ADDENDUM NO. 3

GMIA – Concourse E Restroom Renovation

OFFICIAL NOTICE NO. 6576

DATE OF ADDENDUM: November 10, 2010

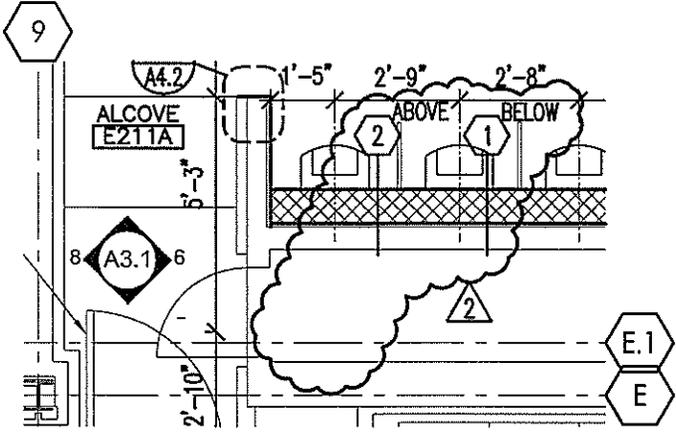
Sheet A1.1 Demolition And Floor Plans

Modify per attached AD-02

TEMPORARILY SHIFT EXISTING REFRIGERATORS FOR INSTALLATION OF URINAL CLEANOUTS (REFER TO PLUMBING), COORDINATE WITH RESTAURANT OWNER FOR SCHEDULE TO RELOCATE EQUIPMENT FOR CLEANOUT INSTALLATION AND RETURNING REFRIGERATORS TO CURRENT LOCATION, SEE MECHANICAL.

WALL RETURNS ABOVE SHELF, REFER TO SECTION FOR WALL TYPES AT URINAL WALL.

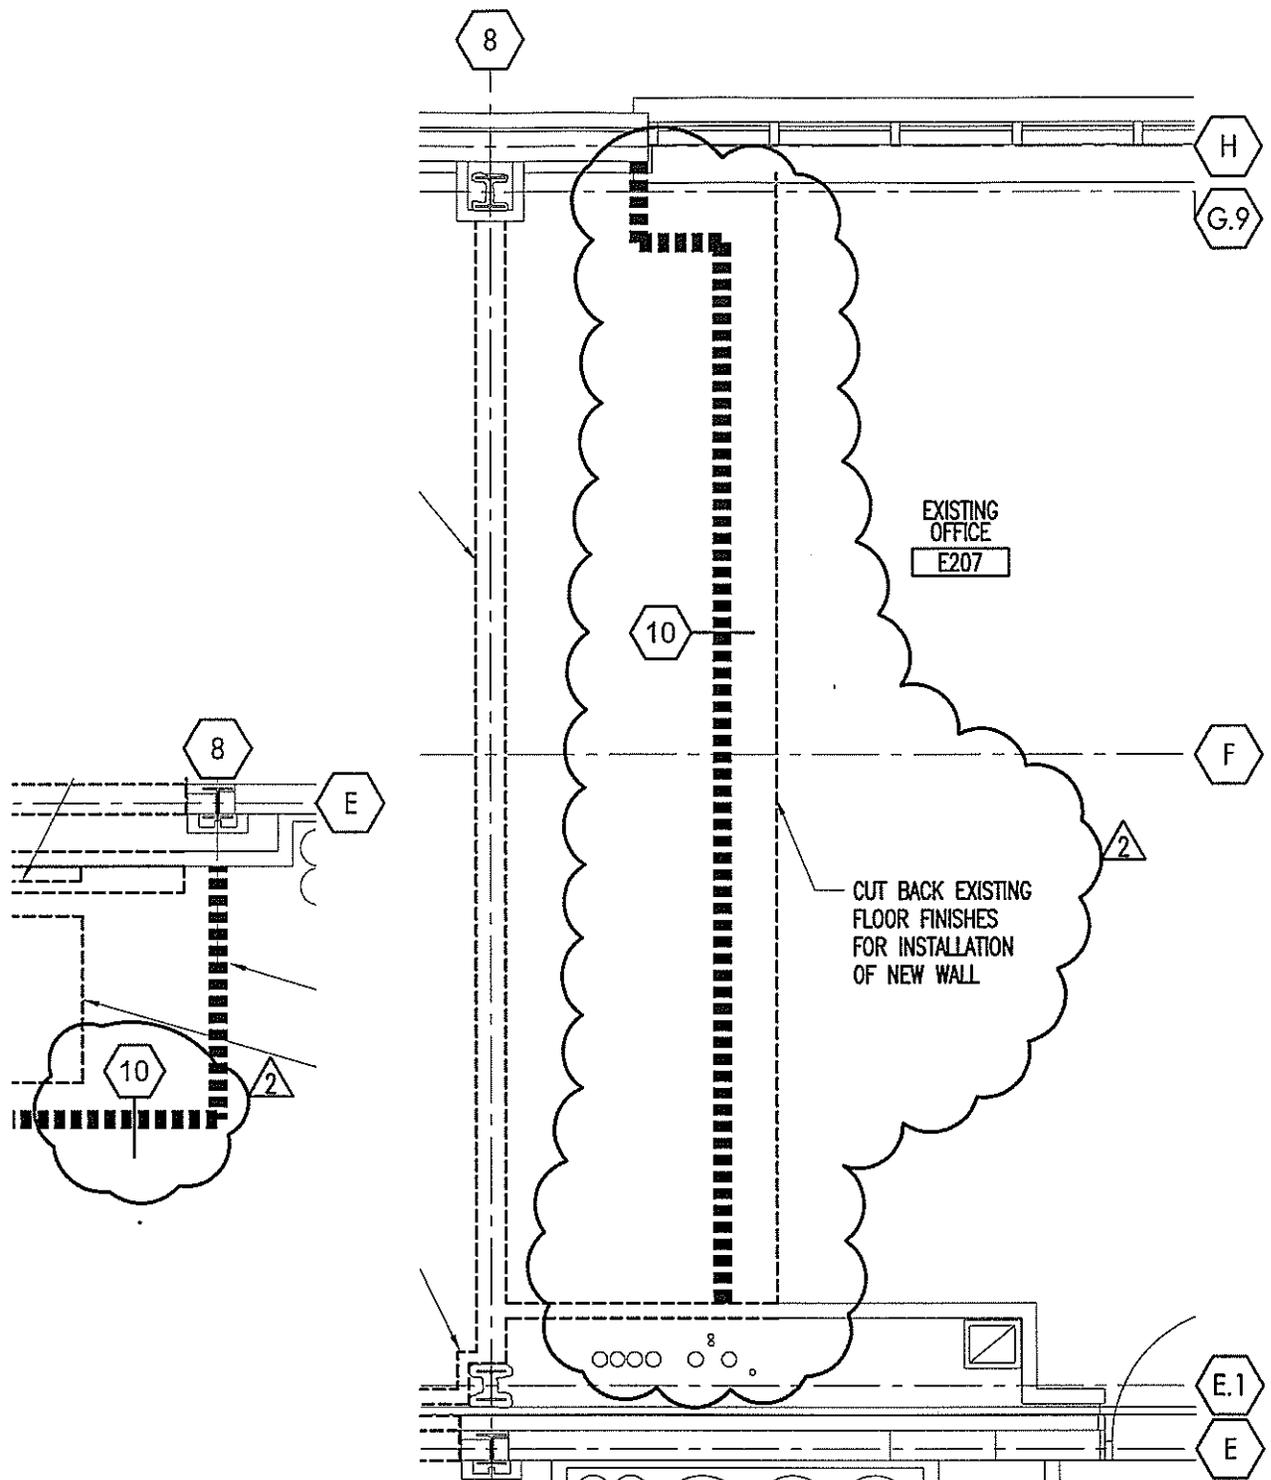
Sheet A1.2 Children's Play Area Demolition And Floor Plans

Modify per attached AD-03 & AD-04

Add the following note to 1/A1.2 demolition plan:

REMOVE AND RELOCATE THE FOLLOWING ITEMS:

ALL TSA OFFICE EQUIPMENT AND FURNITURE AND RELOCATE
SAME IN OFFICE E207 ARRANGEMENT AS DIRECTED BY TSA.
REFER TO SECTION 02250 FOR LIST OF FURNITURE AND
EQUIPMENT

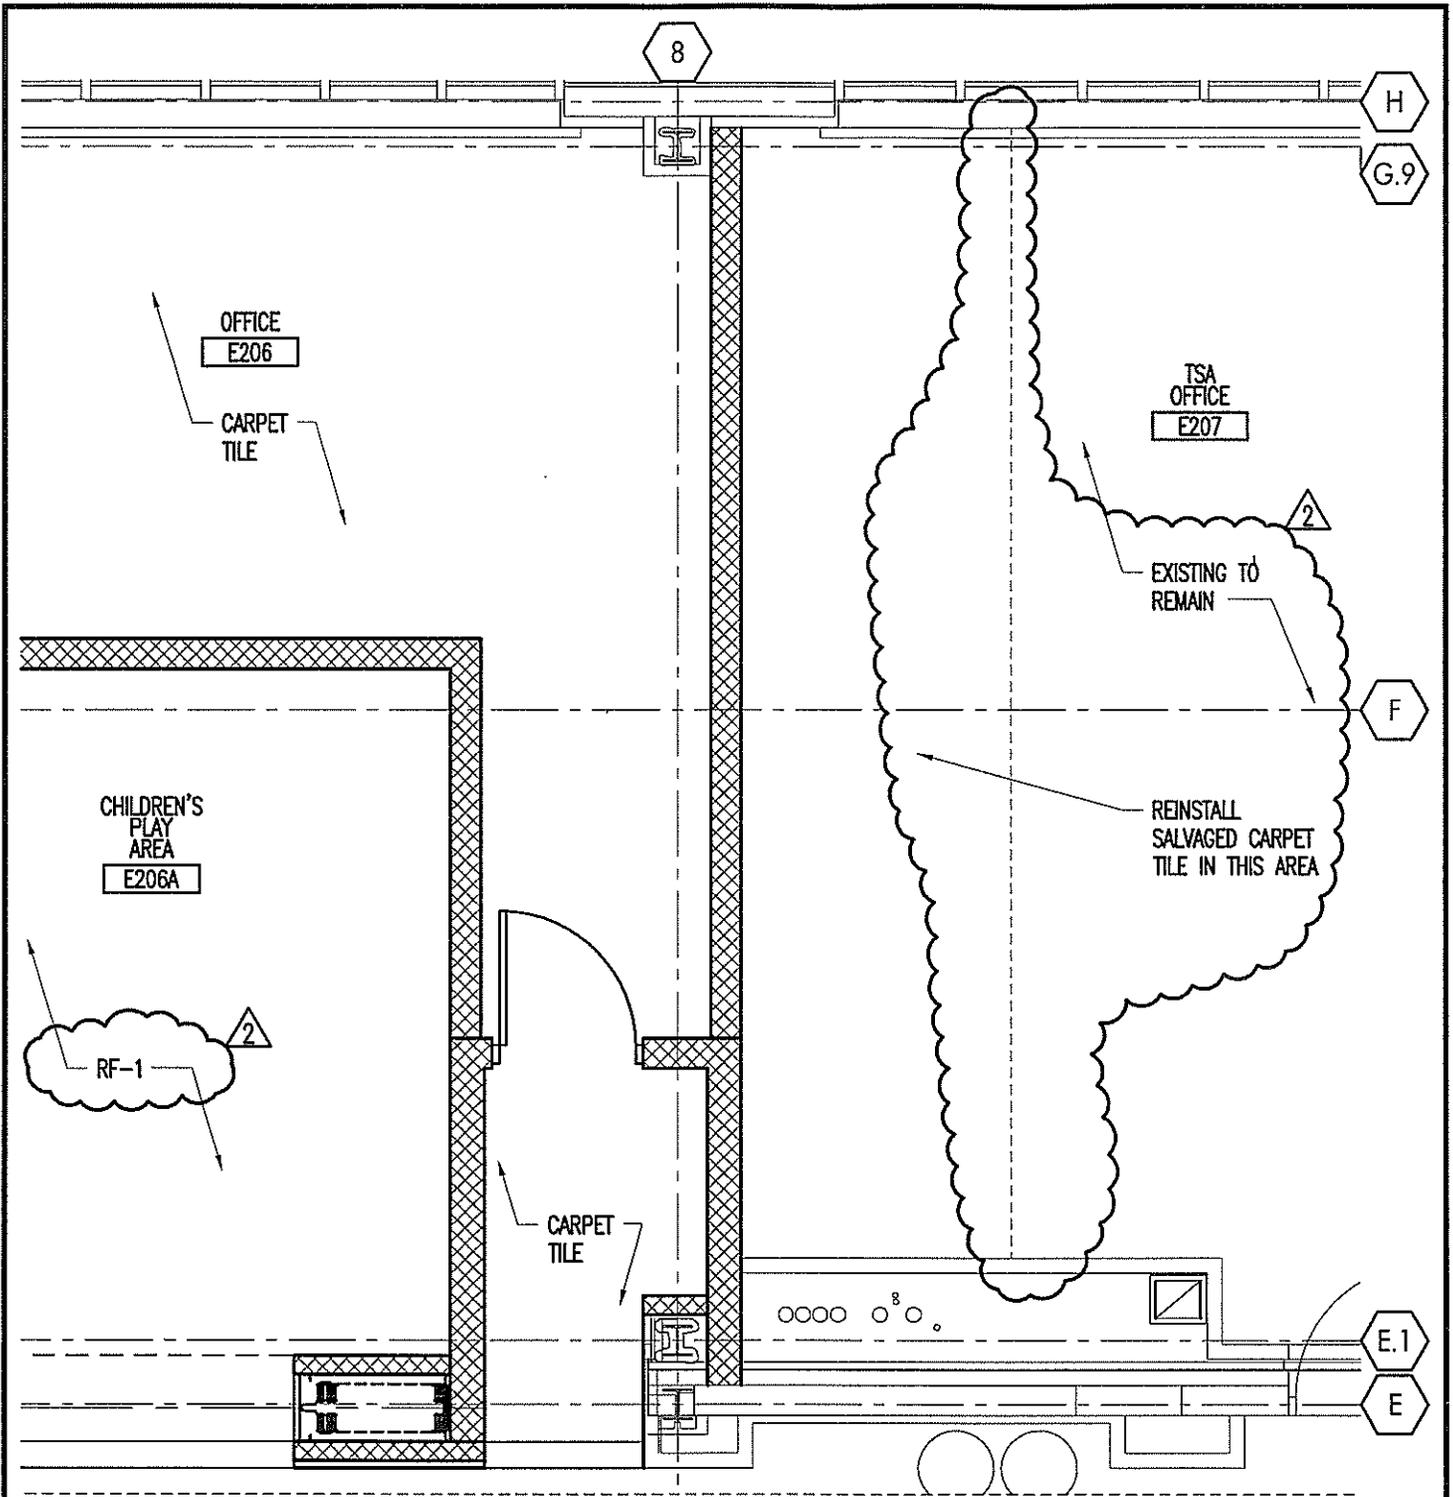
Sheet A2.1 Children's Play Area Reflected Ceiling And Finish Plans

Modify per attached AD-05

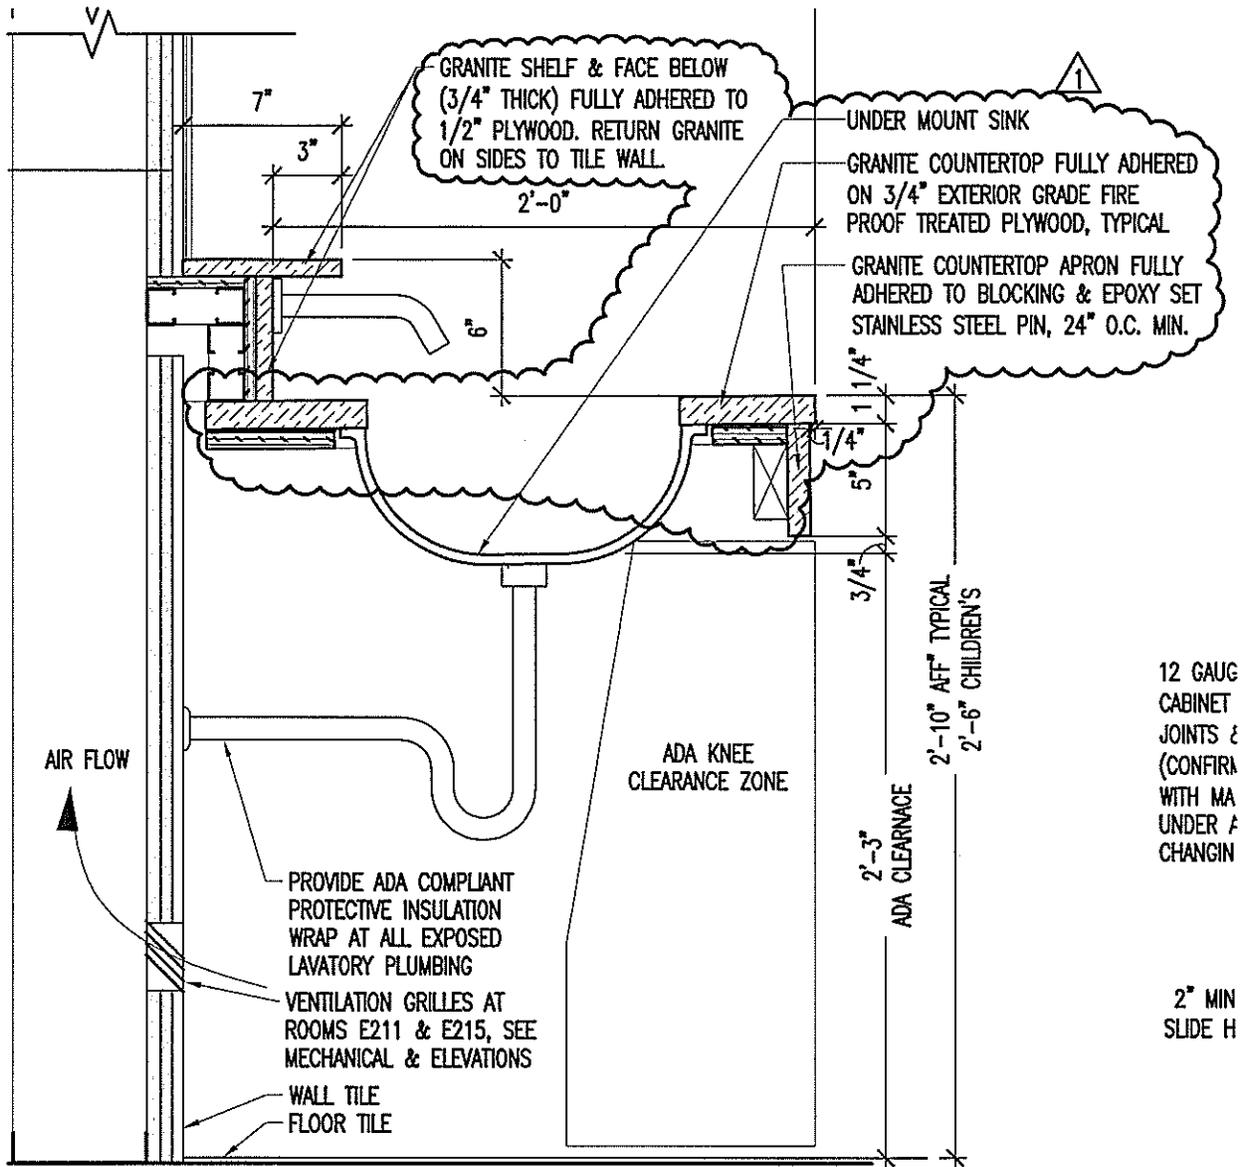
Sheet A4.1 Elevations

Modify per attached AD-06 & AD-07

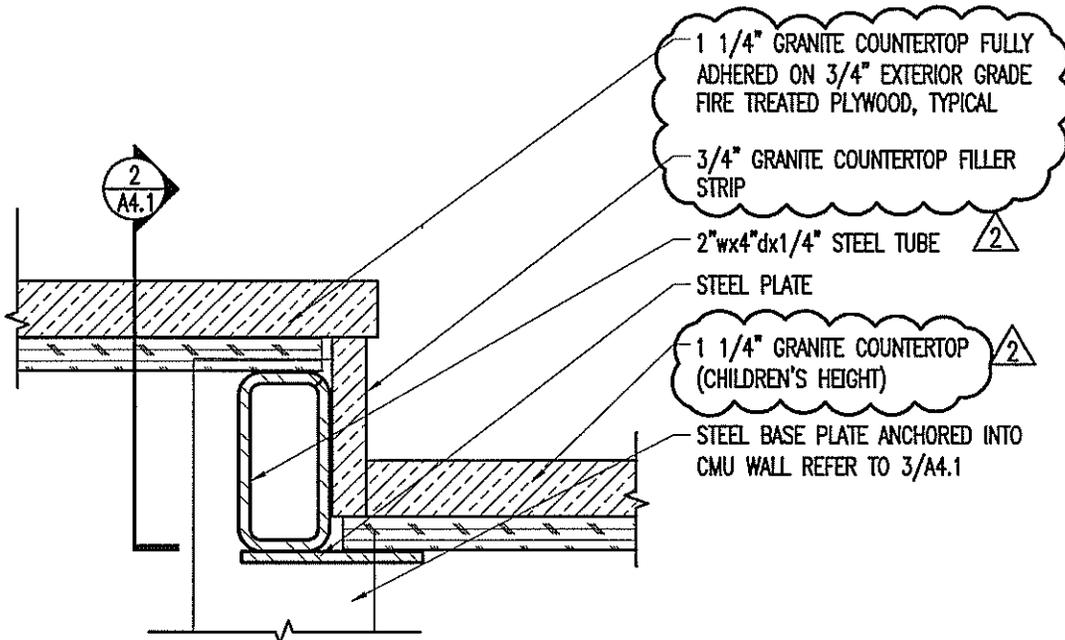
Sheet A4.2 Details

Modify per attached AD-08

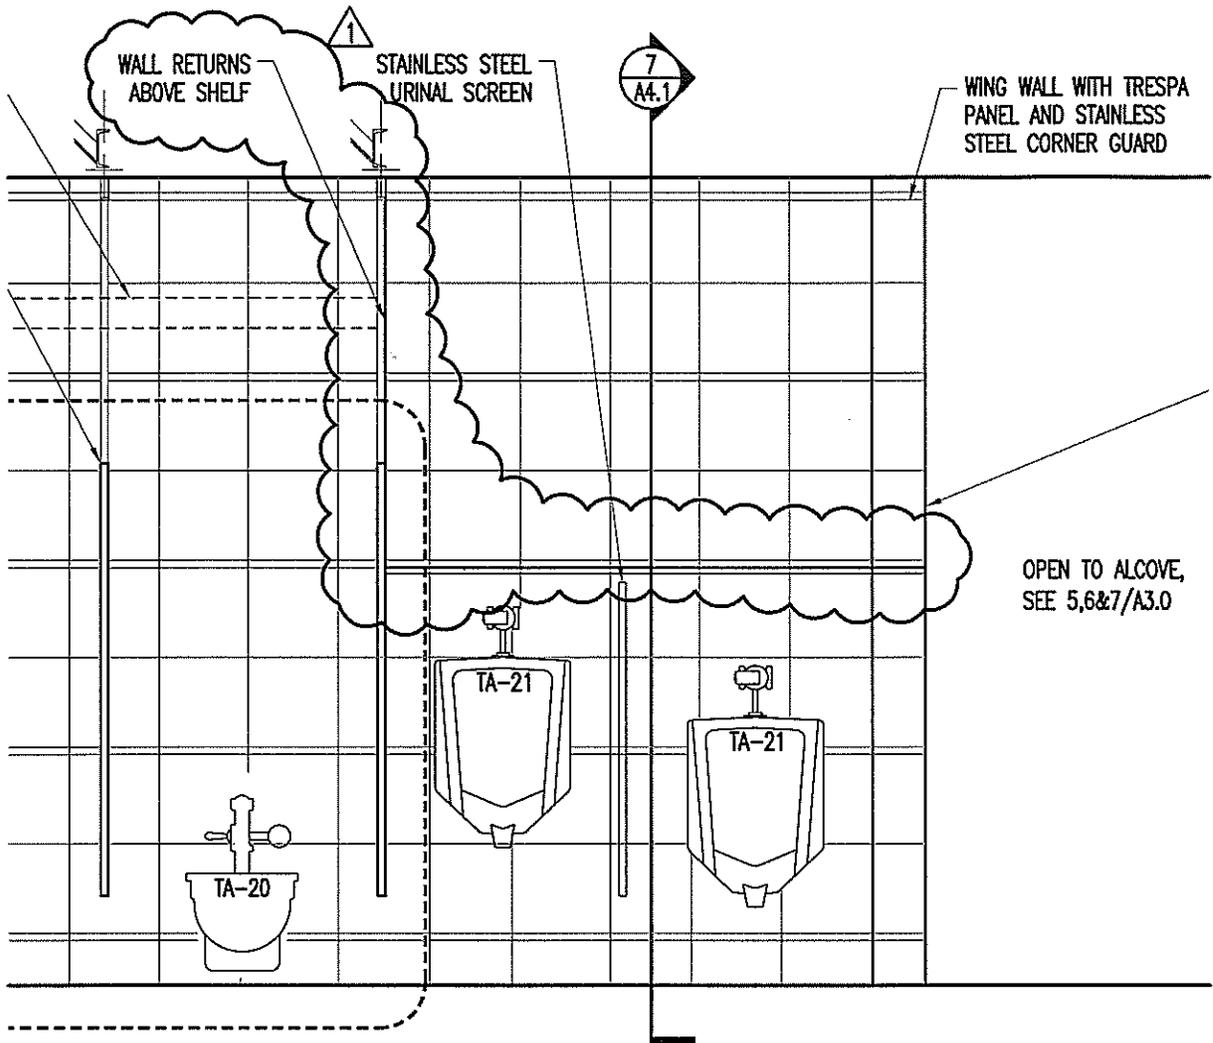
Sheet A3.0 Elevations

Modify per attached AD-09

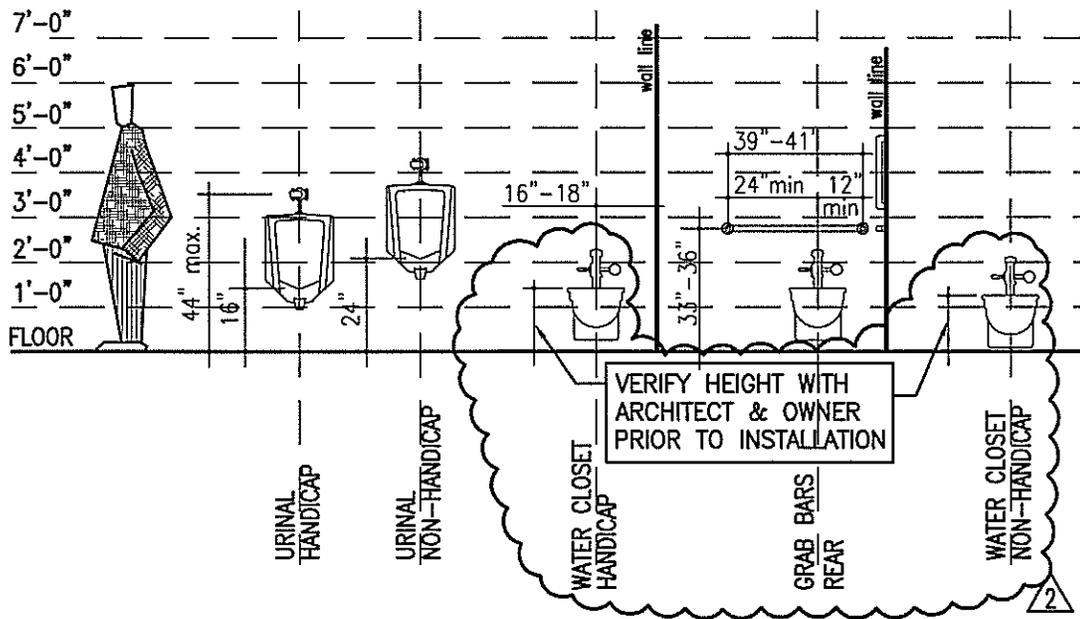
Sheet A4.0 Elevations

Modify per attached AD-10

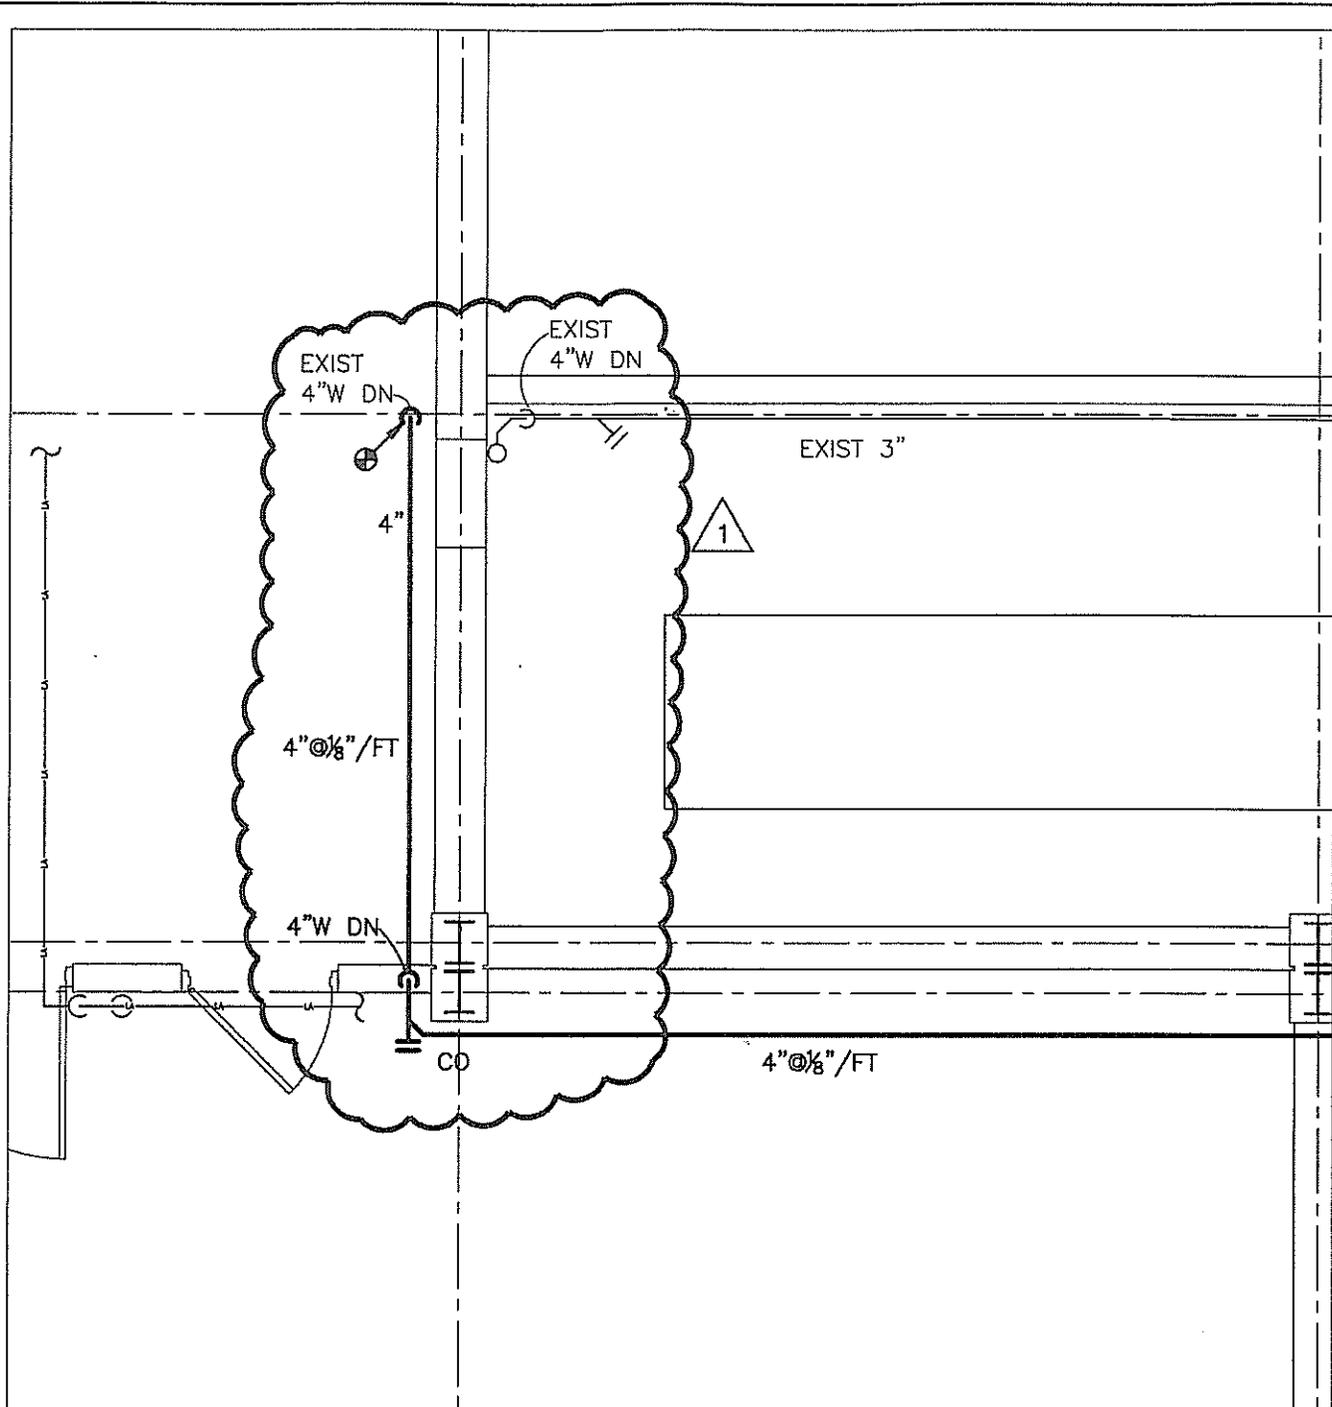
Sheet P2.0 Apron Level Plan – Plumbing

Modify sheet per attached PD-01
